**CITY OF KELOWNA
MEMORANDUM**

Date: February 8, 2008
To: City Manager
From: Planning & Development Services Department
APPLICATION NO. Z07-0011 **APPLICANT:** Axel Hilmer
AT: 605 Monterey Rd. **OWNERS:** Marcel Gal
Bertha Gal

PURPOSE: TO REZONE THE SUBJECT PROPERTY FROM THE RU1 – LARGE LOT HOUSING ZONE TO THE RU6 – TWO DWELLING HOUSING ZONE IN ORDER TO CONSTRUCT A SECOND SINGLE FAMILY DWELLING.

SITE PLAN

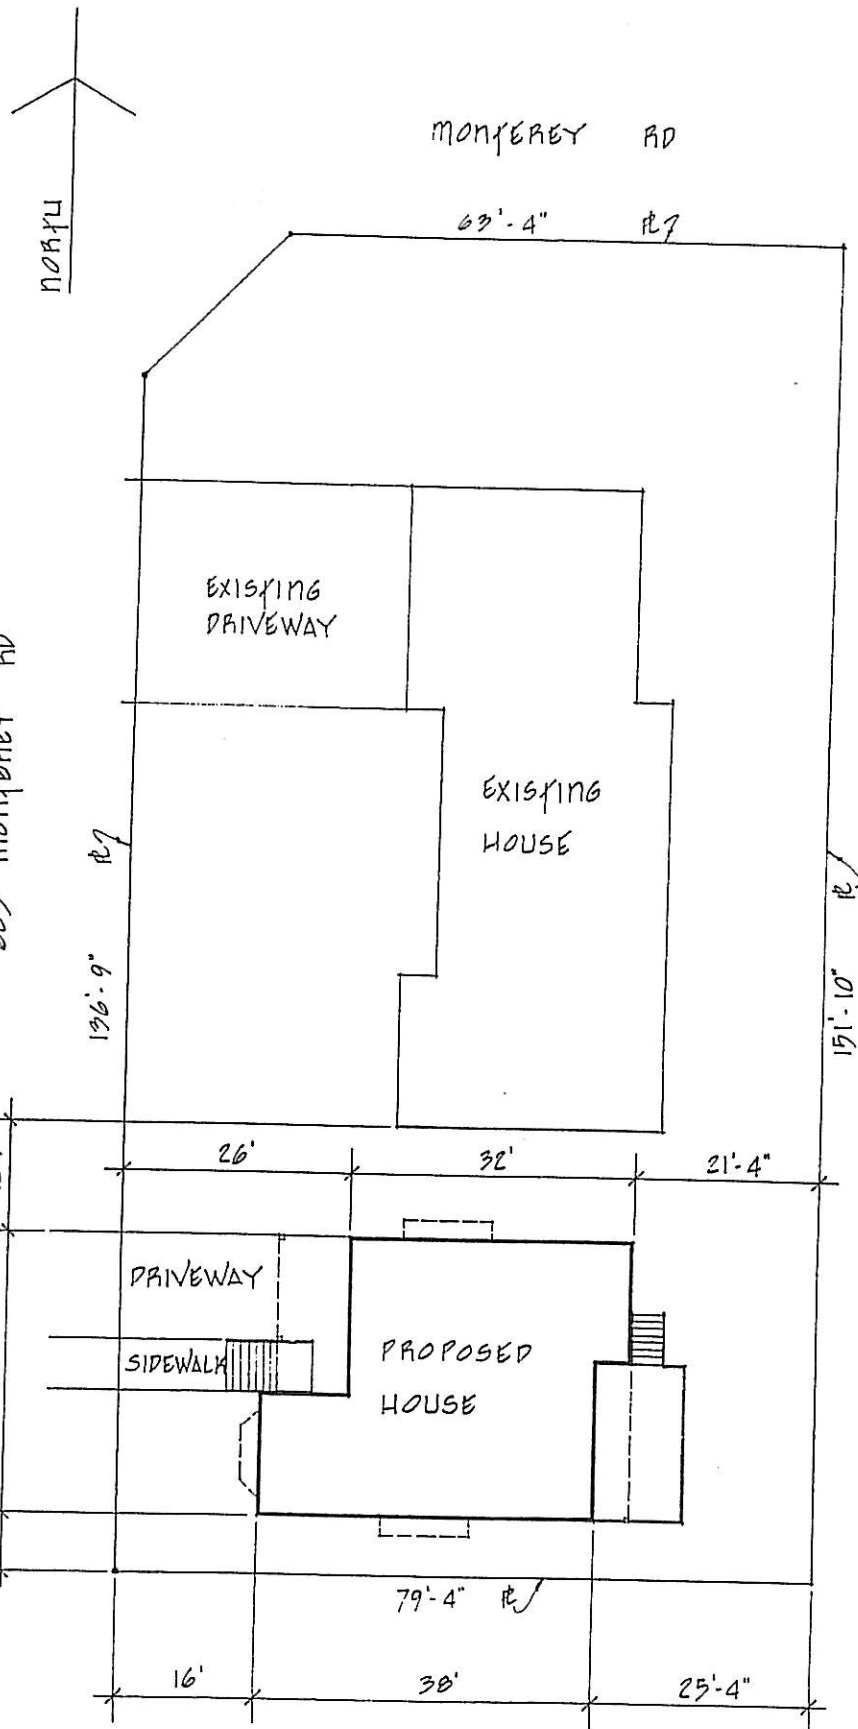
^A The site plan shows a 6.5 m dimension to the proposed house, where the actual measurement should be to the raised deck portion of the structure, which is ± 2.1 m from the east property line.

^B The applicant is seeking to vary the rear yard setback requirement from 6.0 m / 7.5 m to 2.0 m.

^C The applicant is seeking to vary the required separation distance between the two houses from 4.5 m to 3.8 m.
